Mark Robertson
Senior Project Manager, Barangaroo
Lend Lease
30 The Bond, 30 Hickson Road, Millers Point

Barangaroo South - Stage 1a Public Domain Works (SSD 6303), Hickson Road, Millers Point

Re: Barangaroo South - Stage 1a Public Domain Works (SSD 6303), Hickson Road, Millers Point

Figure 1

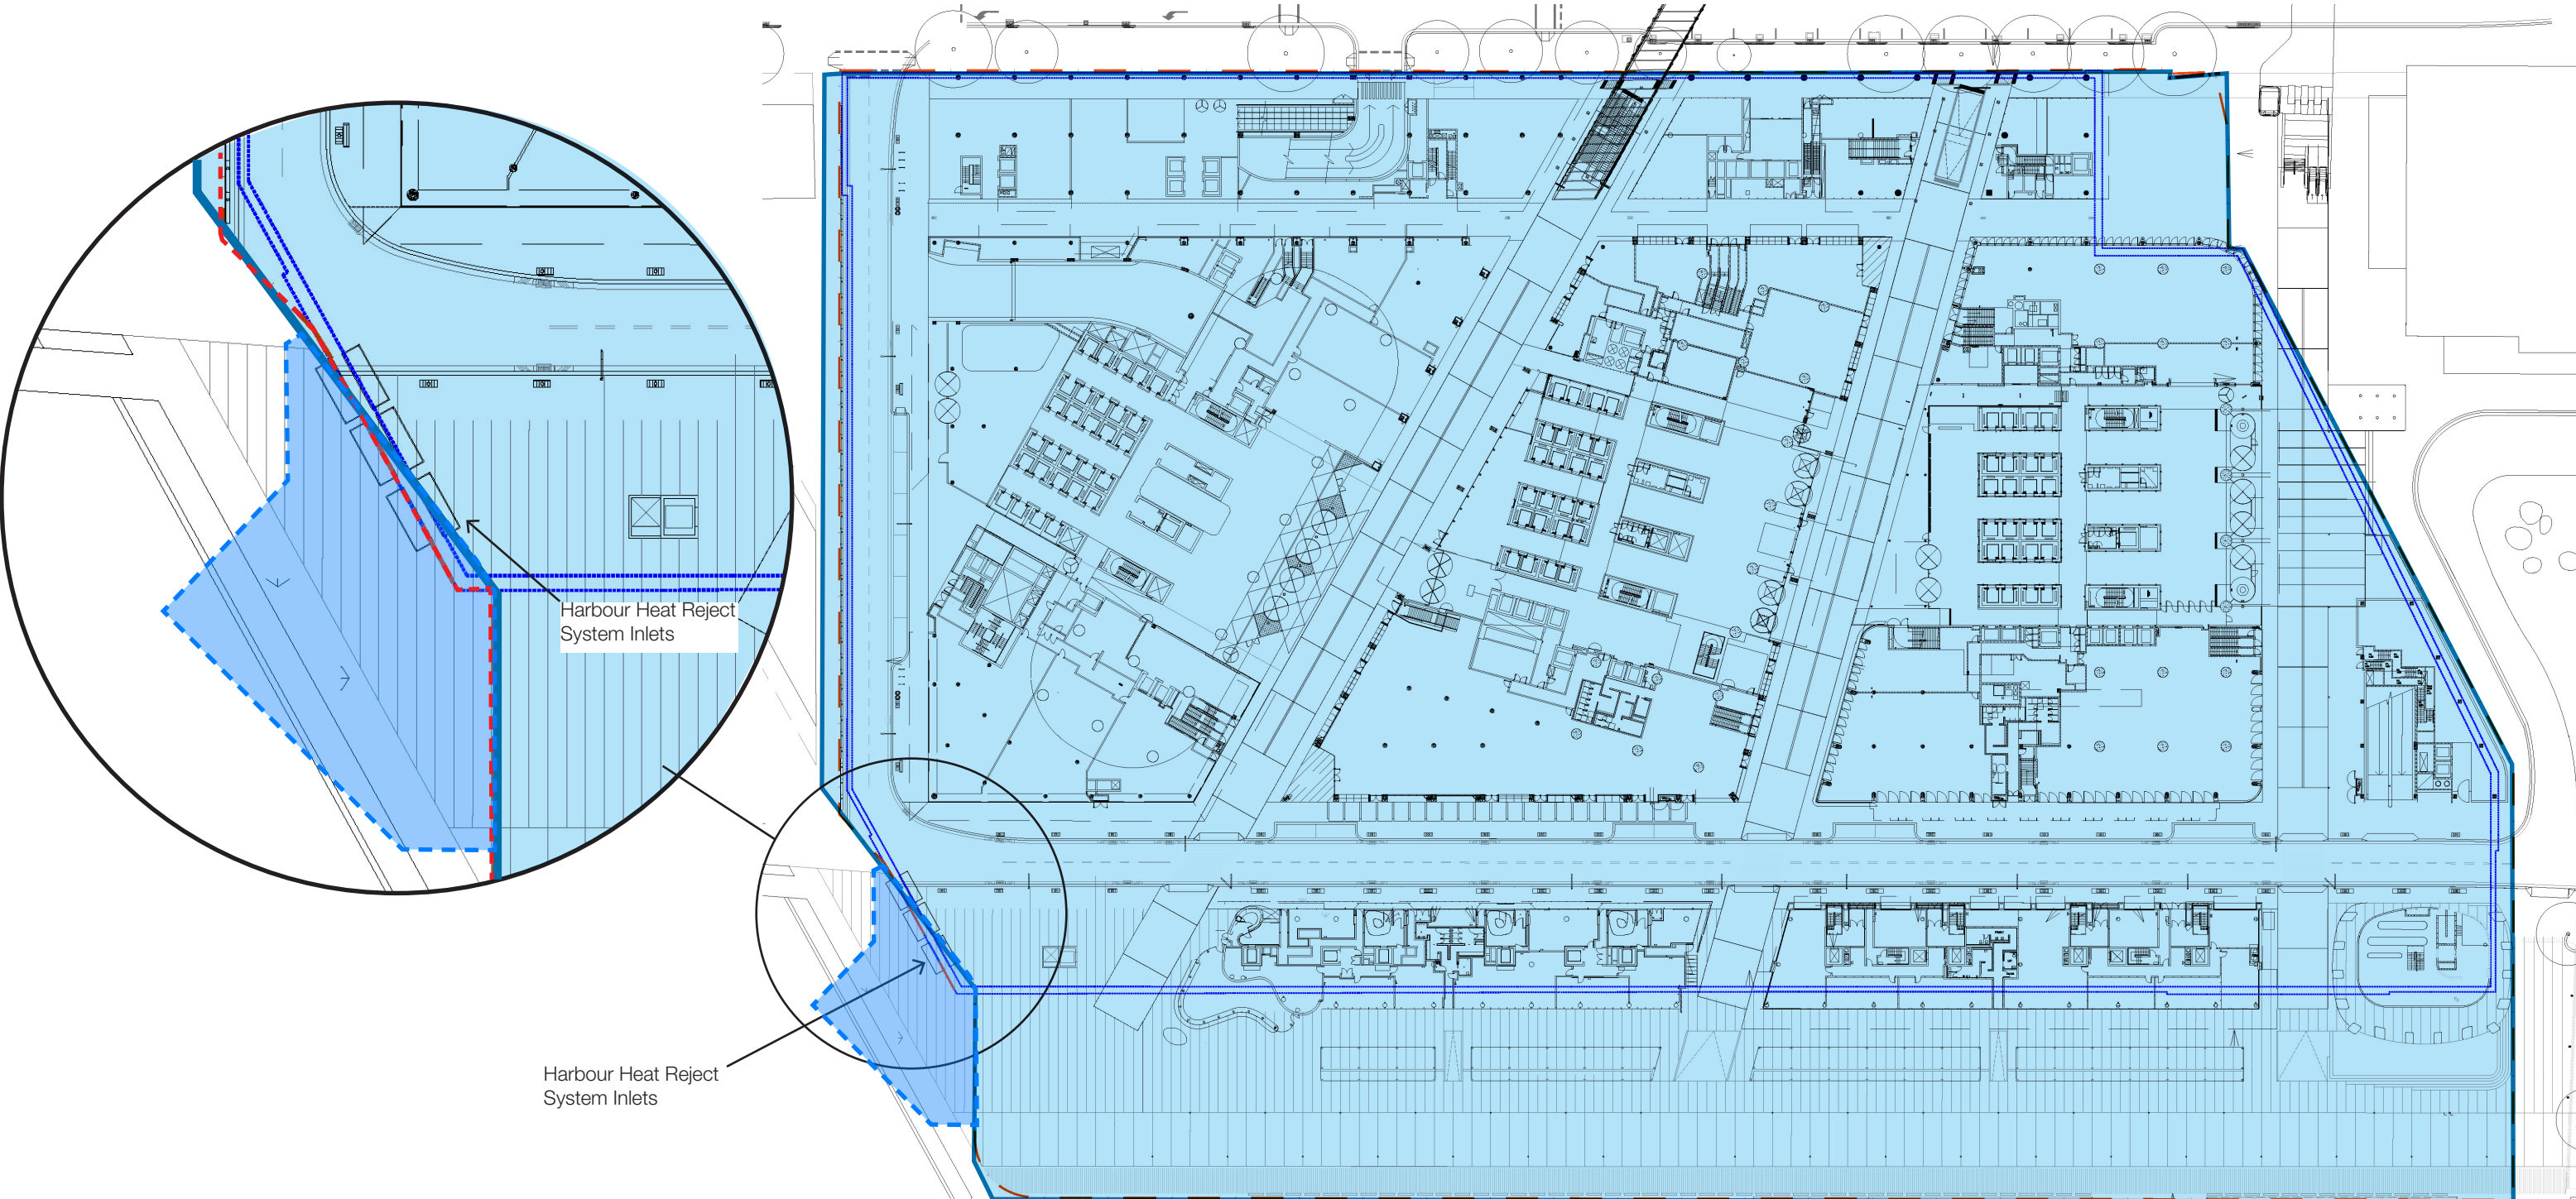
As detailed in the attached **Figure 1** the post-development level of the Stage 1a Public Domain is generally proposed to be in the order of RL 2.9 m AHD which is consistent with that contemplated by the *ORWS Amended RAP* (AECOM, 2011).

Of note, the scope of works proposed by MP10_0023 (MOD 6) include a proposed temporary public domain for the Basement Risers extending outside of the ORWS basement area at (refer to **Figure 1**):

Figure 2

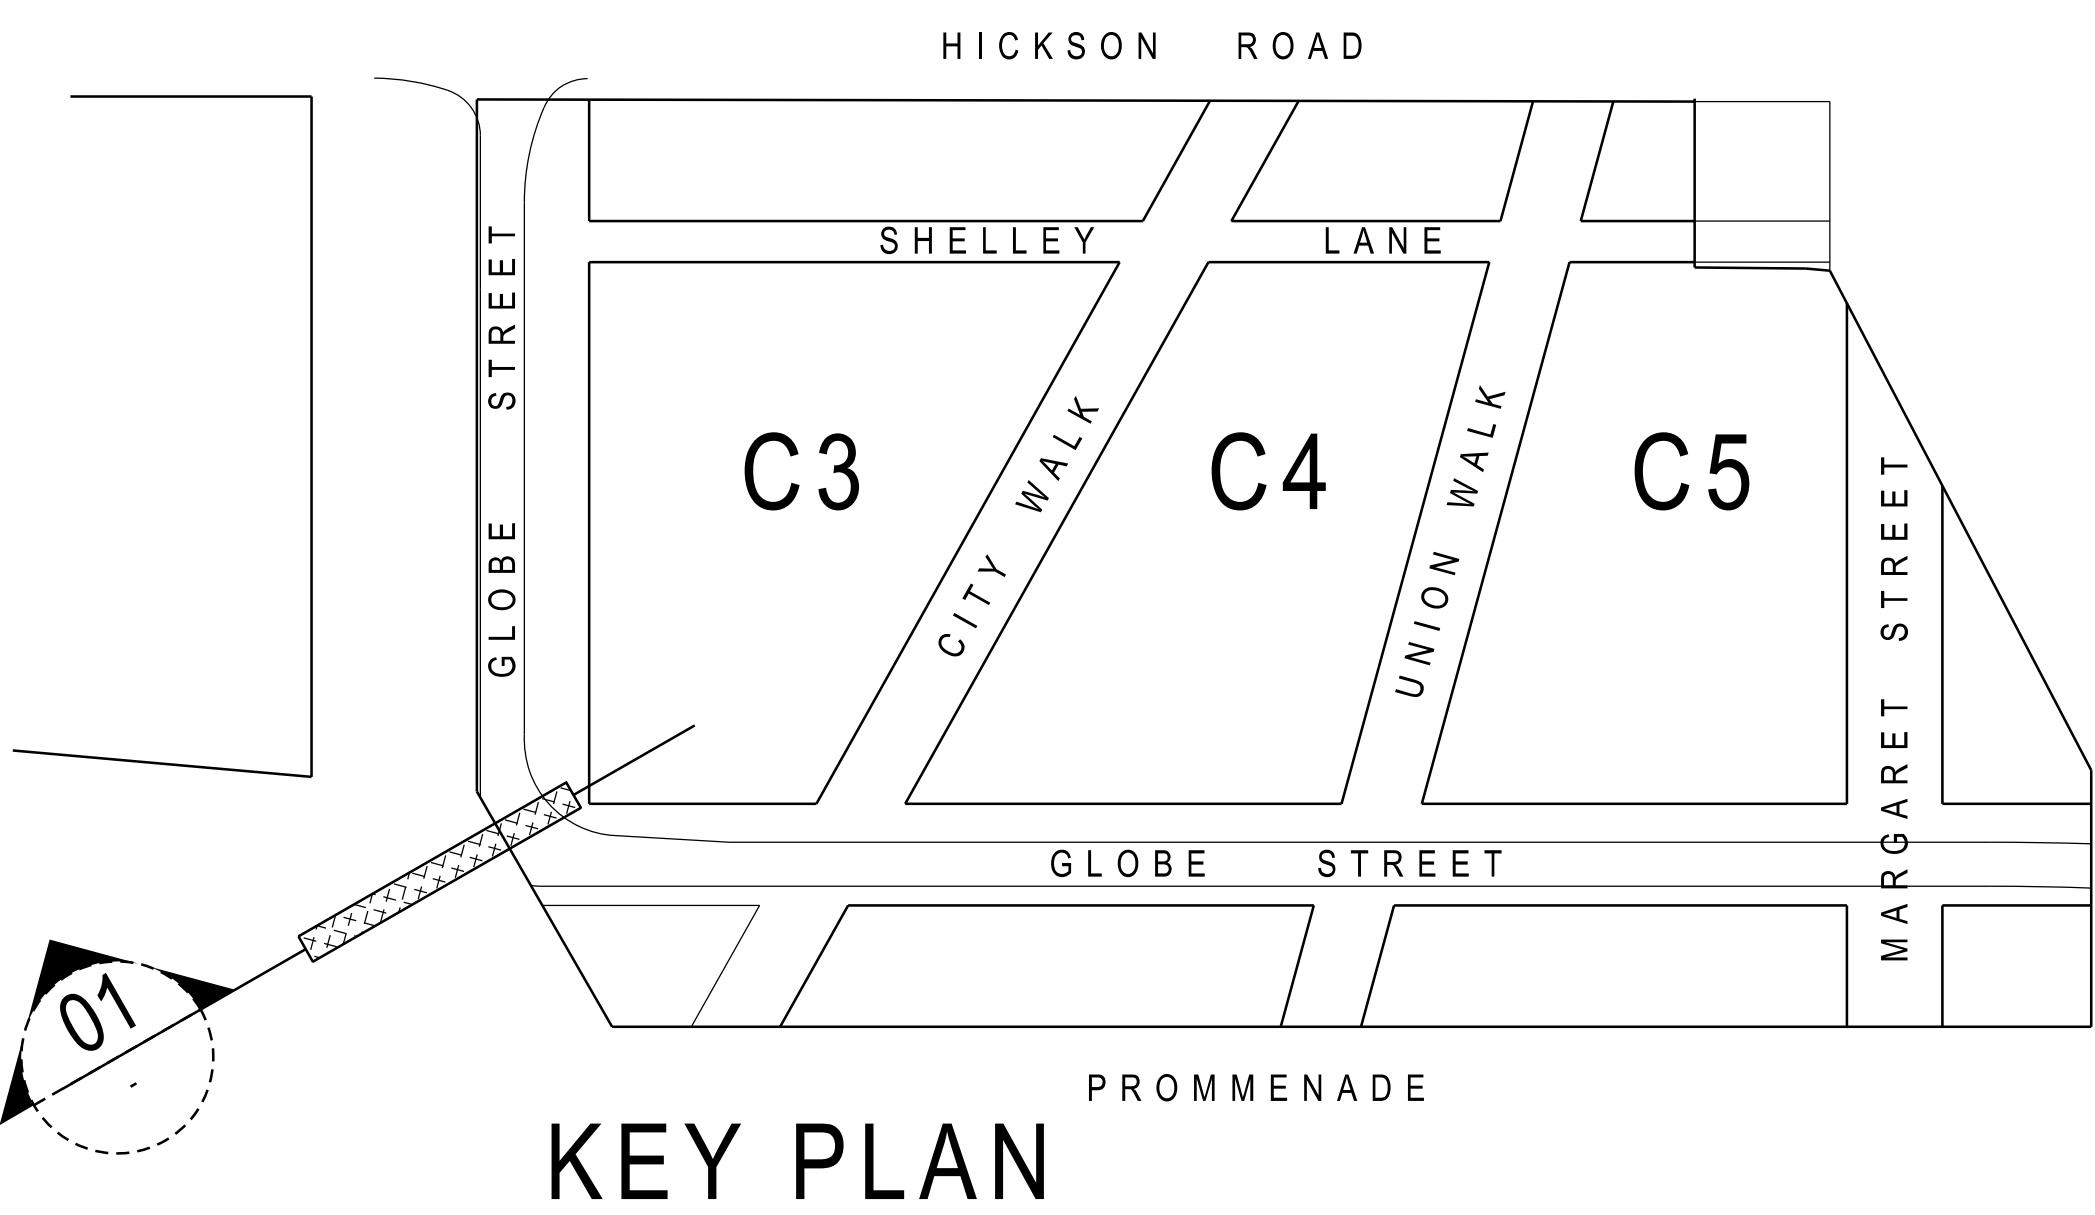
The development plans indicate that the northern extent of the Stage 1a Public Domain development extends slightly beyond the alignment of the Stage 1a basement groundwater retention wall in a limited area at the north west corner of the Stage 1a development area boundary (refer to the attached **Figure 2**). The *ORWS Amended RAP* (AECOM, 2011) was prepared on the basis that the alignment of the Stage 1a groundwater retention wall would correspond with the ORWS Development Area. However, it is considered that the area of work that falls outside the Stage 1a groundwater retention wall can be appropriately managed by the provisions of the *ORWS Amended RAP* (AECOM, 2011). This conclusion is based on the following lines of evidence:

It is noted that a small portion of the ORWS diaphragm wall (the northwest corner) extends north of the alignment anticipated by the *ORWS Amended RAP* (2011) (refer to the attached **Figure 2**). It is considered that this outcome will result in a reduced risk to the environment and human health because:

The development plans indicate that the extent of the Stage 1a Public Domain development extends beyond the alignment of the Stage 1a basement groundwater retention wall in an area along the southern Stage 1a development area boundary (refer to the attached **Figure 2**). The *ORWS Amended RAP* (AECOM, 2011) was prepared on the basis that the southern alignment of the Stage 1a groundwater retention wall would correspond with the southern boundary of the ORWS Development Area. However, it is considered that the area of work that falls outside the Stage 1a groundwater retention wall can be appropriately managed by the provisions of the *ORWS Amended RAP* (AECOM, 2011). This conclusion is based on the following lines of evidence:

Figure 3

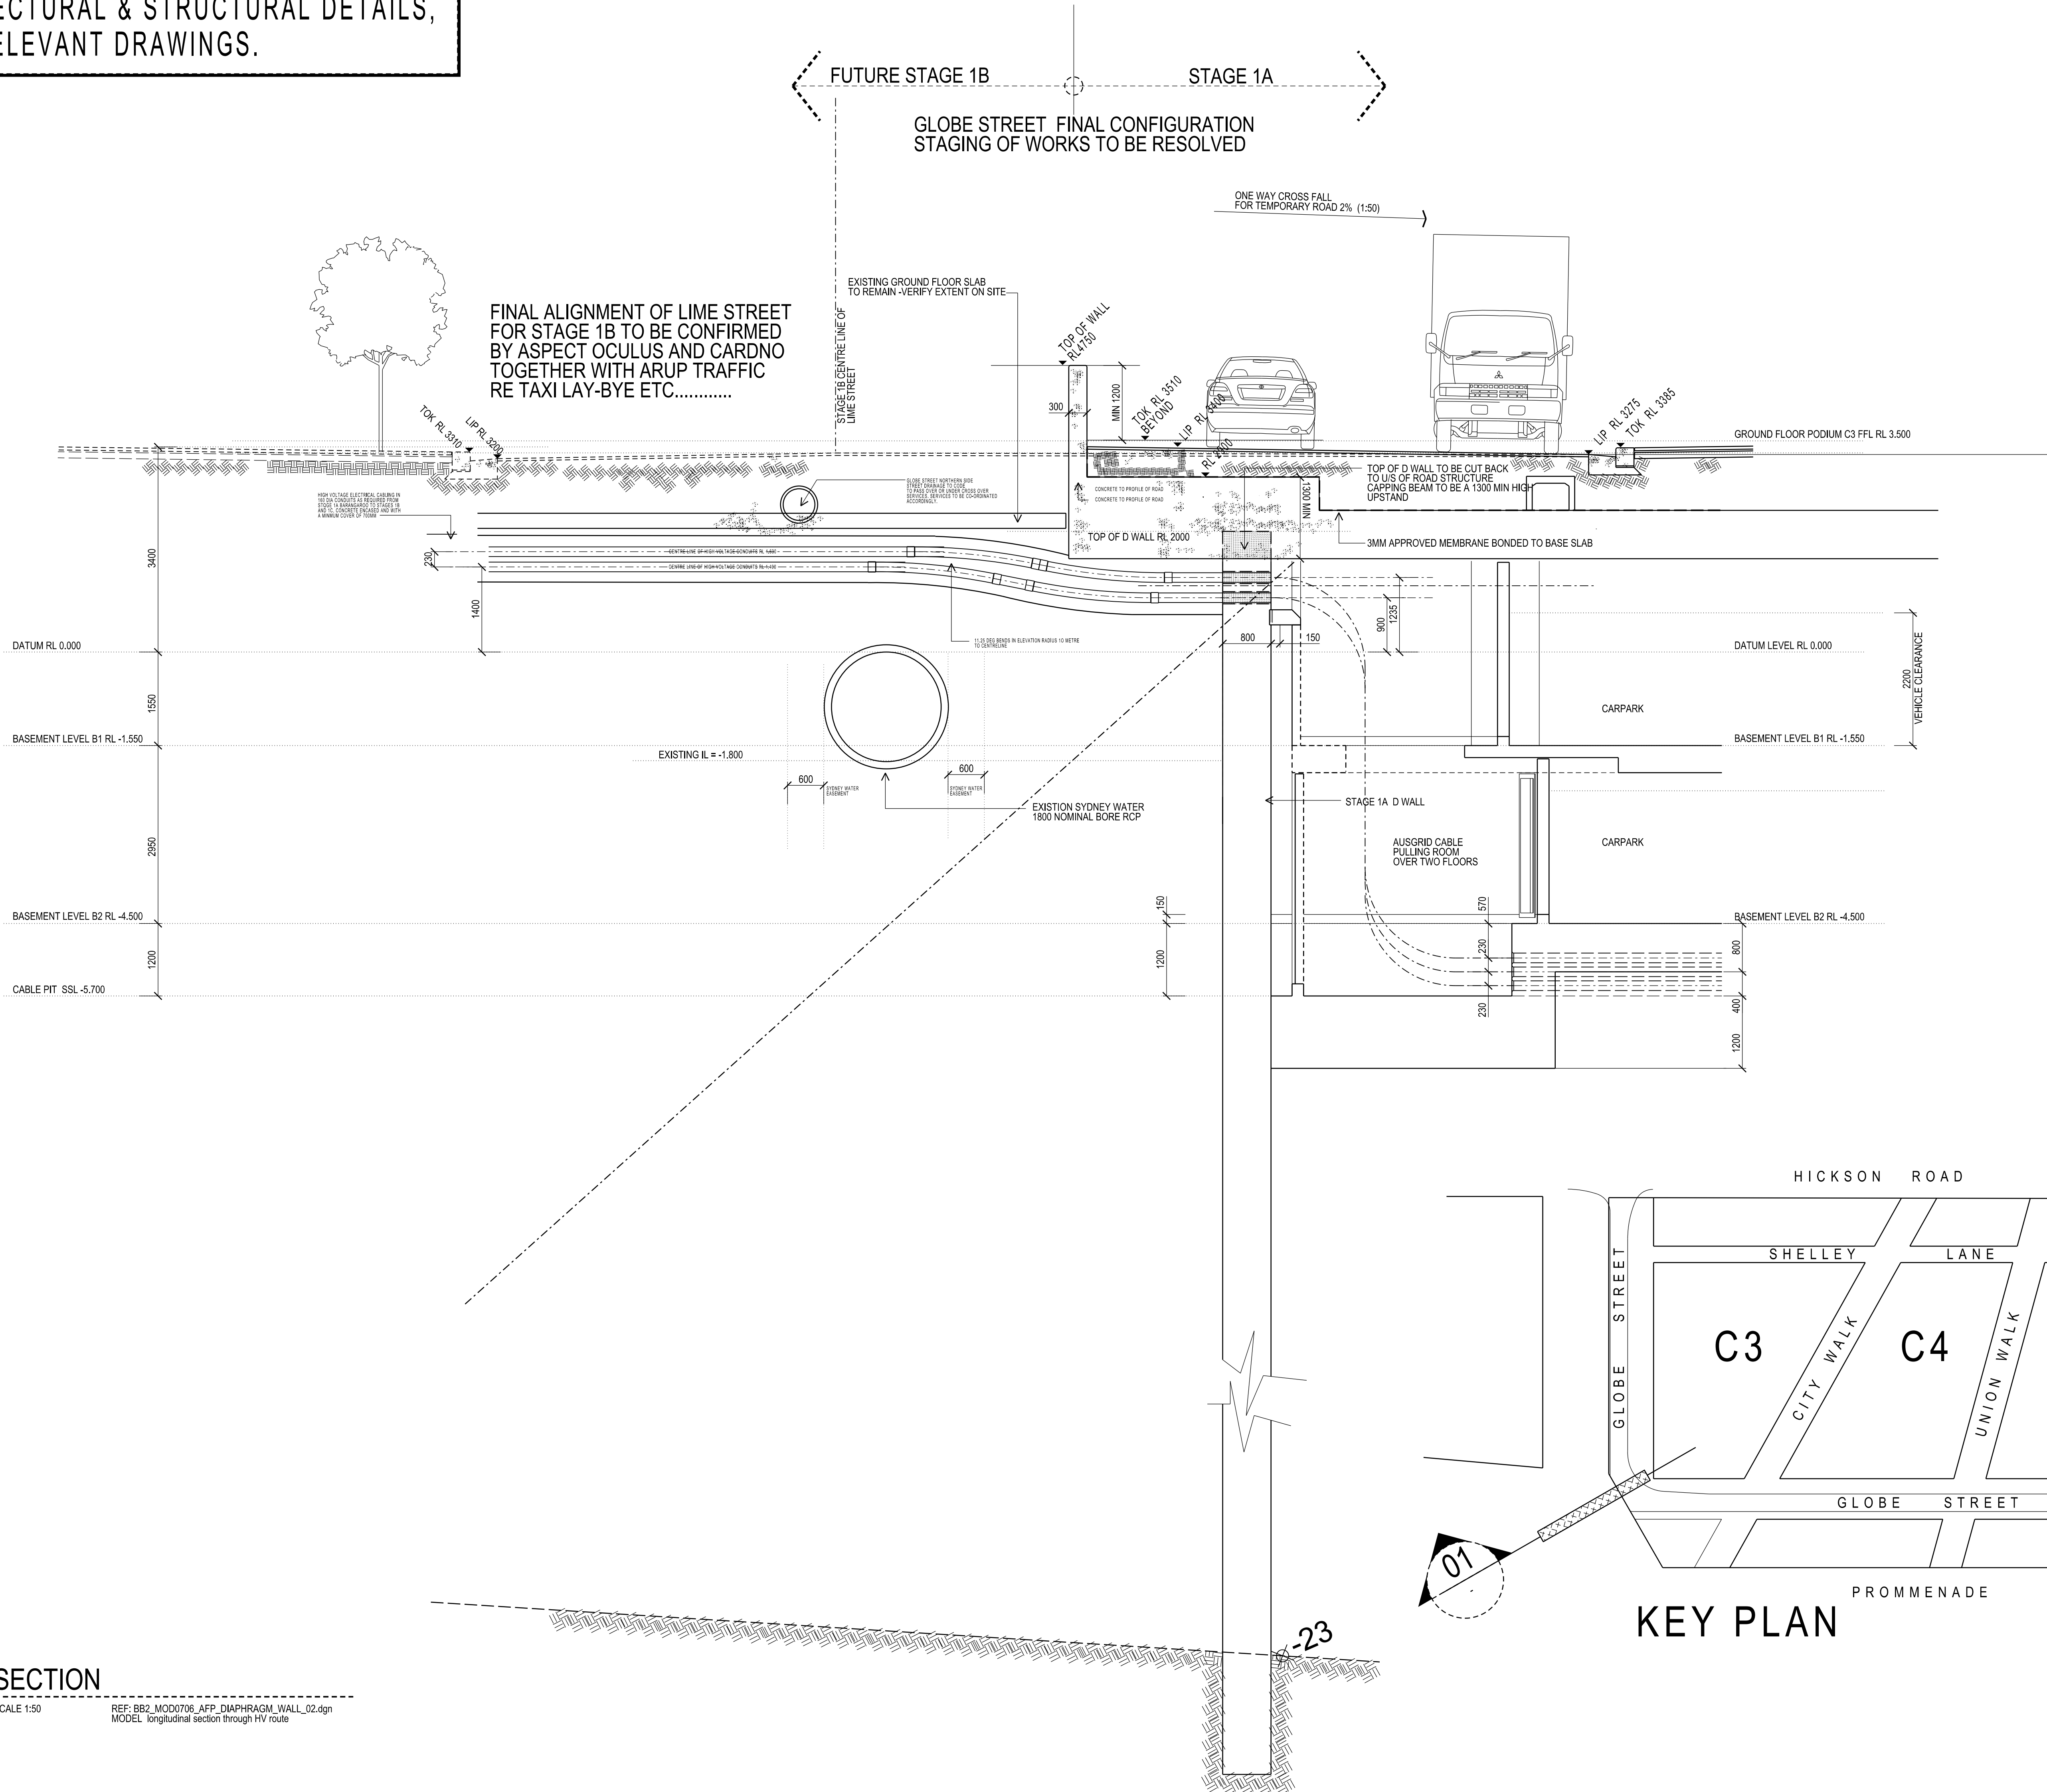
- Soil analytical data relevant to the discussed area is presented on **Table T1** and **Figure 3**, attached (taken from Figure F3 of the *Addendum to the Amended ORWS RAP* [AECOM, 2012]). Particular locations considered to be representative of the area are BH01, BH04, BH035, BH049, BH047 and BH37. Review of the available soil analytical results (both saturated and unsaturated material) indicates that Chemicals of Potential Concern (CoPC) concentrations are generally less than the 'Area A' Site Specific Target Criteria (SSTC) and relevant Site Specific Ecological Screening Criteria (SSESC, as detailed in Table T1 of the *ORWS Amended RAP* (AECOM, 2011). The only exceptions to this are:
